We sincerely thank you for the opportunity to revise our manuscript (*Reframing gullies as recharge zones in dryland landscapes of the Loess Plateau, China; egosphere-2025-4065*). We are deeply grateful for the detailed and constructive feedback provided by the reviewers, which has been invaluable in strengthening and improving our work. In response to the reviewers' comments, we have thoroughly revised the manuscript and made the necessary changes. All comments have been addressed point-by-point. Reviewer comments are presented in red, our responses in black, and the revisions to the manuscript in blue. The line numbers in our responses refer to the revised manuscript with no changes marked.

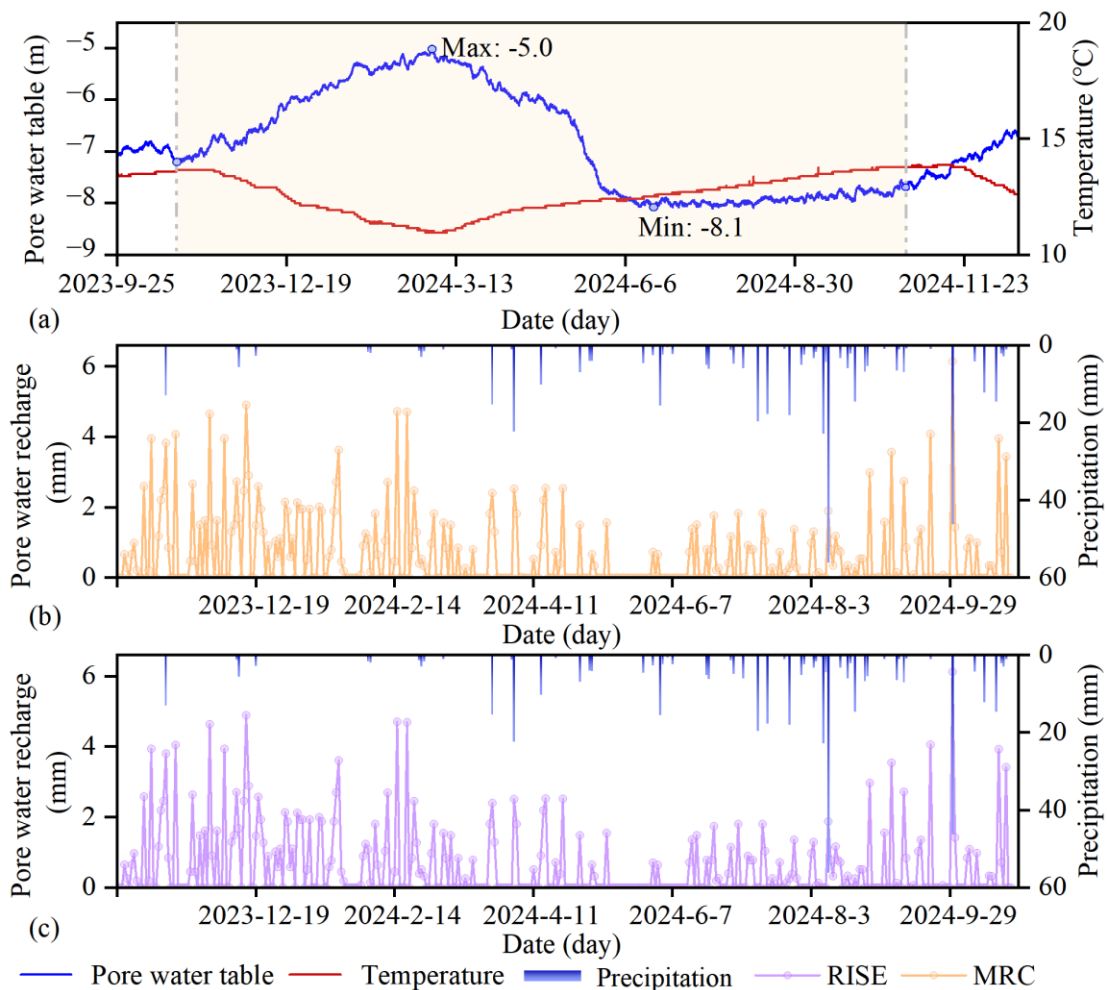
6. Fig. 9: The lines representing the “RISE” and “MRC” methods are not clearly distinguishable in the figure.

Response: In the original manuscript, the “RISE” and “MRC” curves were plotted on the same axis to facilitate a direct comparison of their results. As you rightly observed, the close similarity between the two methods made the lines difficult to distinguish, which compromised the clarity and effectiveness of the information presented.

Based on your comment, we have redrawn and optimized Fig. 9 (in the original manuscript, and now Fig. 10 in the revised manuscript) and revised its caption accordingly. The specific revisions are as follows:

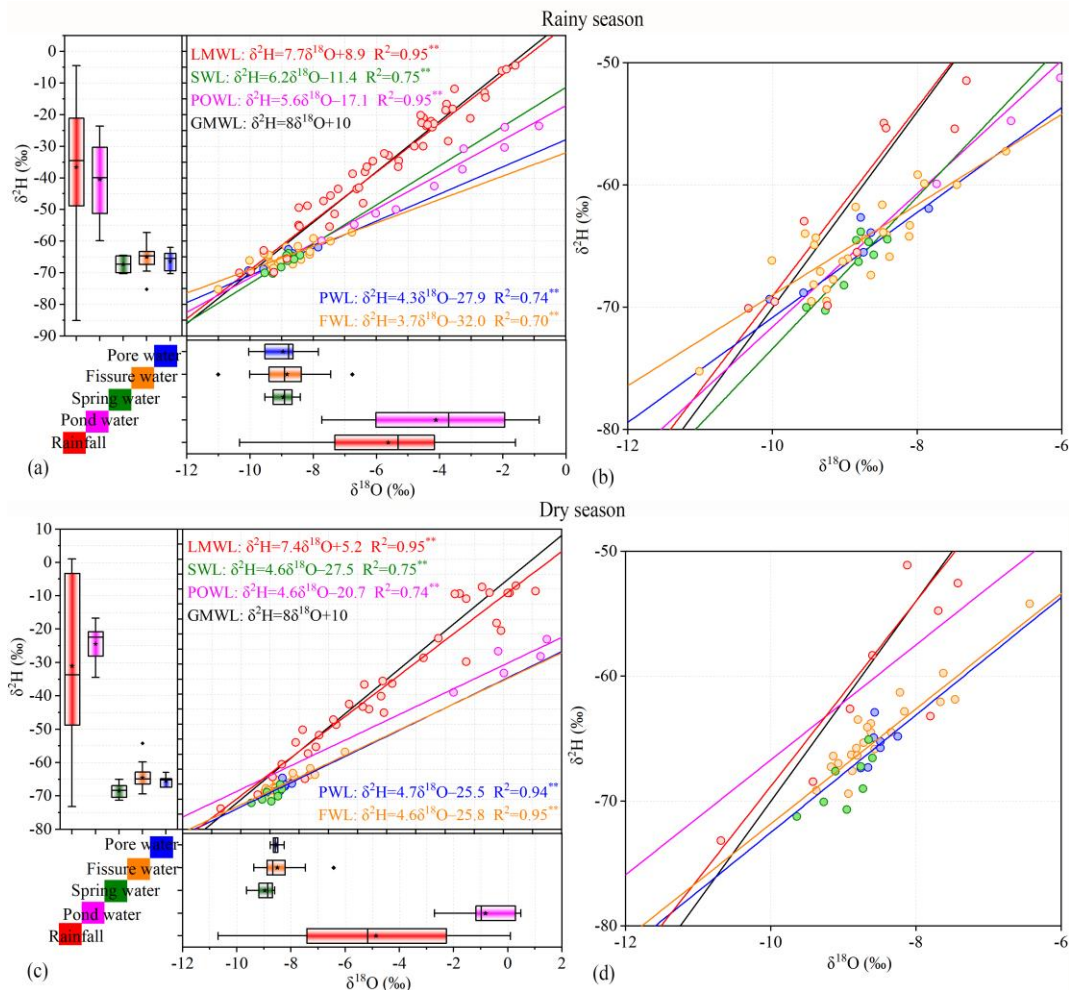
3. It is unclear why the legend colors in Figure 6 cover the text instead of being right-aligned.

Response: Thank you for your detailed comment regarding the format of Fig. 6. In the original manuscript, the legend (colors) in Fig. 6 represented both the x-axis categories of the $\delta^2\text{H}$ boxplot and the y-axis categories of the $\delta^{18}\text{O}$ boxplot, creating a composite legend. To avoid confusion, we have placed the explanatory text above the legend to clarify that it applies to both subplots. As suggested, we have also centered the text in Fig. 6 for better clarity. The specific revisions are as follows:

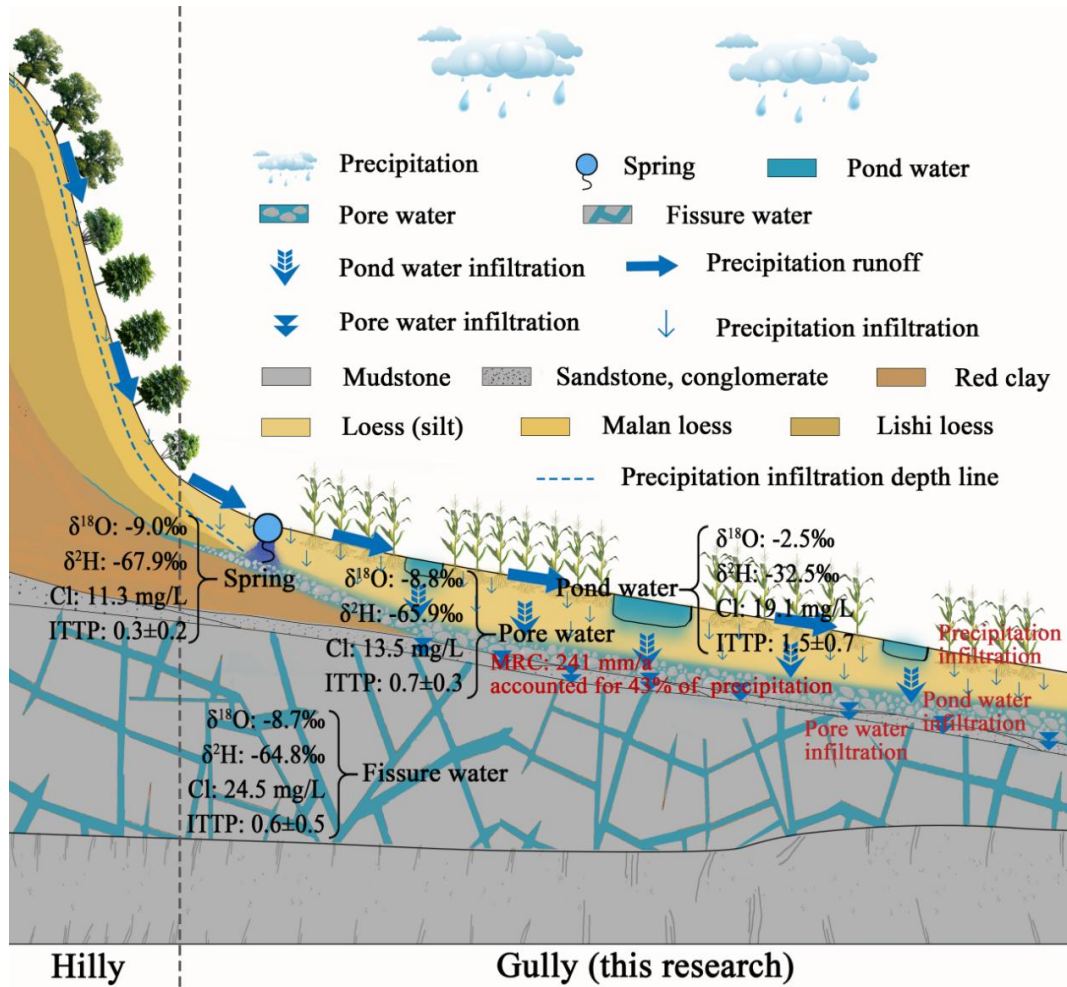
4. Redrawing Figure 10 to include the main findings of this study would be beneficial.

Response: We have revised Fig. 10 (original manuscript, and now Fig. 11 in the revised manuscript) based on your comment, systematically integrating the main findings of this study into the conceptual model. Additionally, we have addressed the updates to Fig. 10 (now Fig. 11 in the revised

manuscript) in the discussion section to ensure consistency between the figure and the text. The specific revisions are shown below:
